**FTV-250**  
**CIRCUIT DIAGRAM**

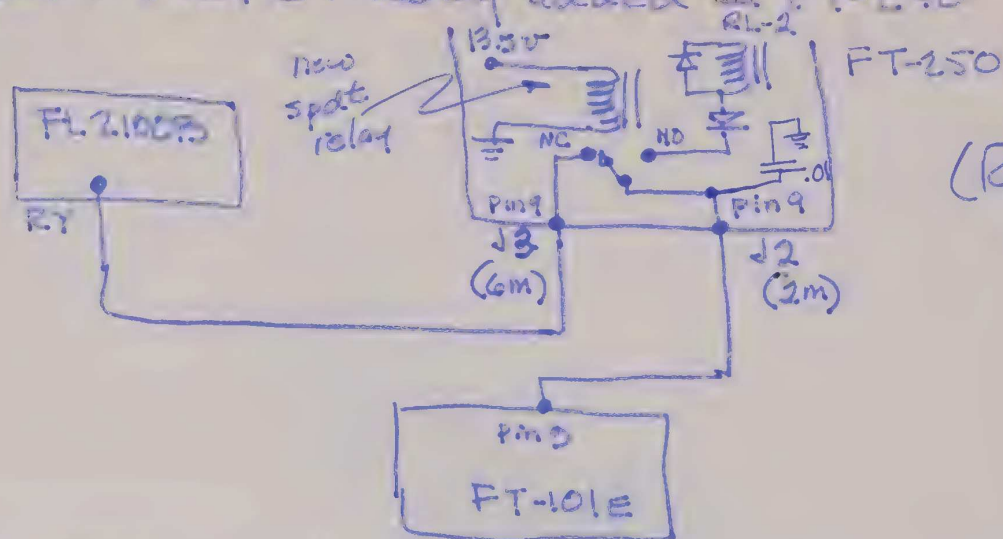
Modified to operate either FT-250 or FL-2100B  
 from FT-101E. Relay added in FT-250

When FT-250 is off, no 13.5V is available in 250 so relay is not energized & NC contact connects RY of 2100B to FT-101E for HF operation. When FT-250 is switched to 144-148, 13.5V energizes relay & switches 101E to FT-250

CHANGED RCA PLUG TO SO-239 ON TRX OUT TO AVOID UMI  
 CABLES (J5)
